# Updated PD state diagram v100

## Info (not part of baseline)

*Change Figure 33–16 as follows:*

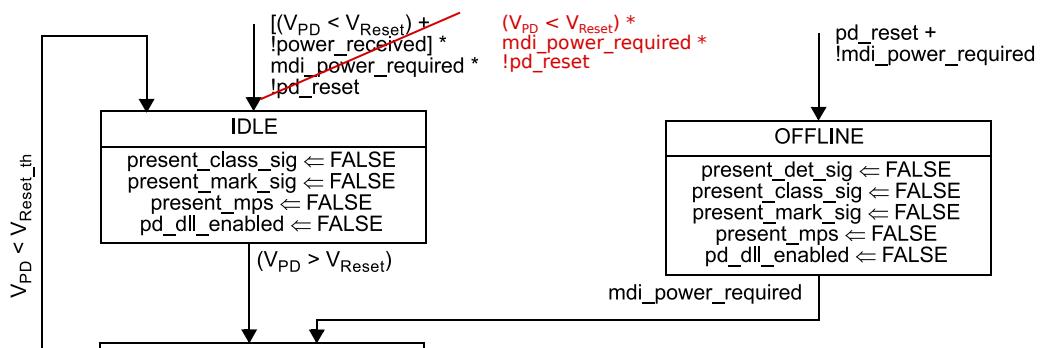
Any open arrow (an arrow with no source block) represents a global transition. Global transitions are evaluated continuously whenever any state is evaluating its exit conditions. When a global transition becomes true, it supersedes all other transitions, including UCT, returning control to the block pointed to by the open arrow.

In other words: unless a PD is powered, the SM will continuously flip back to the IDLE state.  
This entry arrow into IDLE has existed since 802.3at
